New York State Department of Environmental Conservation  
-----

FINGER LAKES LPG STORAGE, LLC

Application Number  
8-4432-00085

**GAS FREE SENECA'S SUR-REPLY BRIEF**

**Figure 3: Cavern 58 Roof Collapse History**  
(Annotated Excerpt from Cross-Section AA’)

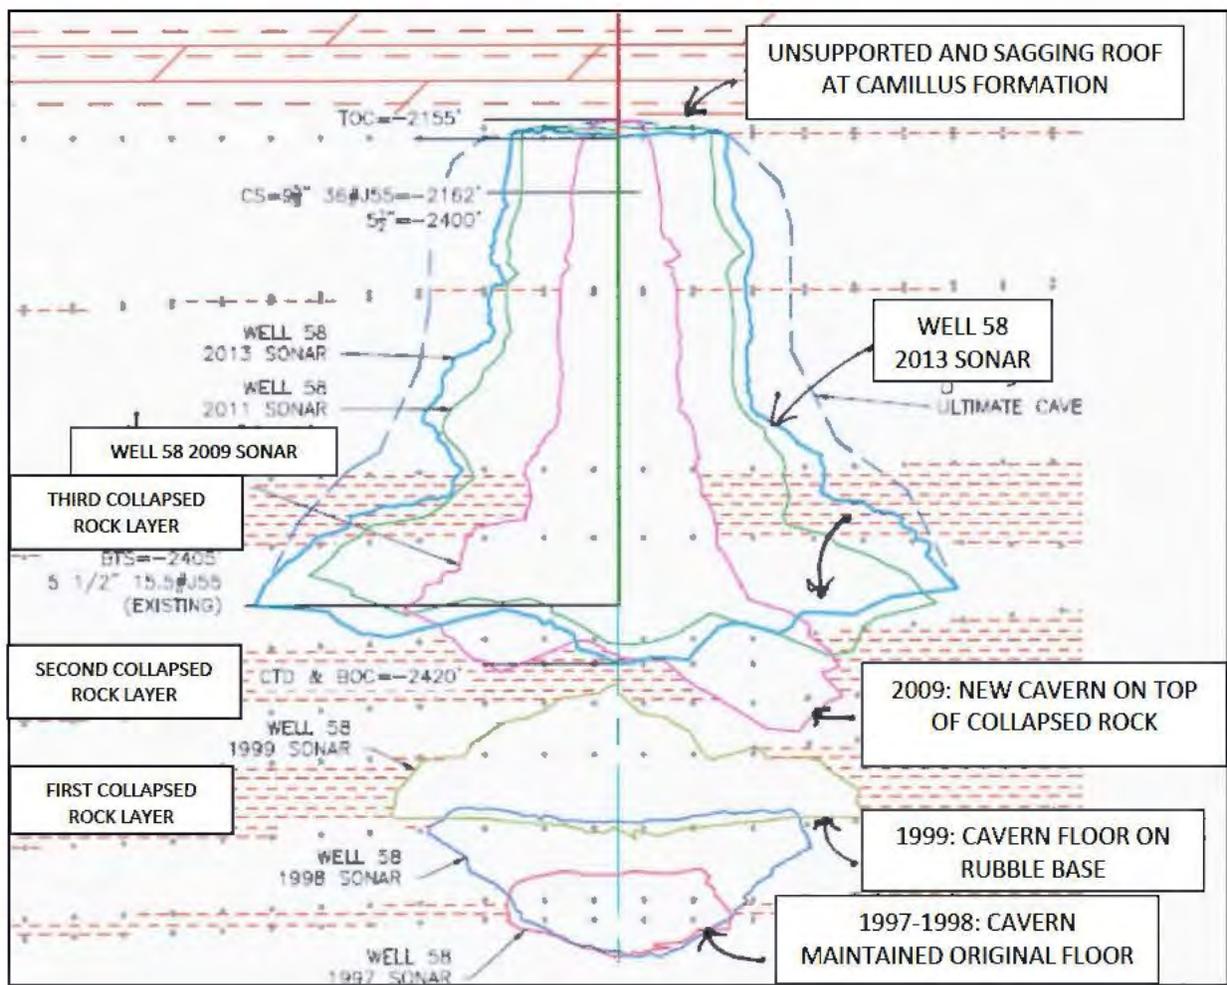
[REDACTED] there is abundant record evidence that rock fell suddenly and repeatedly from its walls and ceiling. As can be seen in Figure 3 on the following page, the rock roof of the cavity shown in the 1998 sonar collapsed, with the top of the resulting

rubble pile forming the floor of the cavity shown in the 1999 sonar. See Clark Report, Ex. E (demonstrating DEC’s understanding that “the older cavity of October 1998 had been nearly filled with shale and salt rubble in the sho[r]t period between earlier sonar surveys”). Thereafter, the layer of rock that formed the ceiling of the cavern shown in the 1999 sonar also collapsed,

very likely producing the rubble that prevented Mr. Larry Sevenker from obtaining a sonar survey in 2001. A third layer of rock, which would have formed the roof of the cavern when solutioning began through the current tubing string, collapsed to permit salt dissolution all the

way to the Camillus formation as early as 2009. No other explanation accounts for the rubble-filled portion of the cavern, [REDACTED]

The documented, but nevertheless disputed, history of collapse in Cavern 58 raises questions about its long-term integrity, because its current roof has reached the Camillus formation, and the rock there already is sagging. Although the FLLPG caverns have been described as cavities in bedded salt, *see* Final DSEIS Text (Document List IV.A.1) at 148, Gallery 2 extends upward beyond the salt, and whether the unsupported Camillus formation safely can serve as the new roof and part of the cavern walls, when the current roof yields to the force of gravity, is a disputed question of fact.<sup>8</sup> *Id.* [REDACTED]
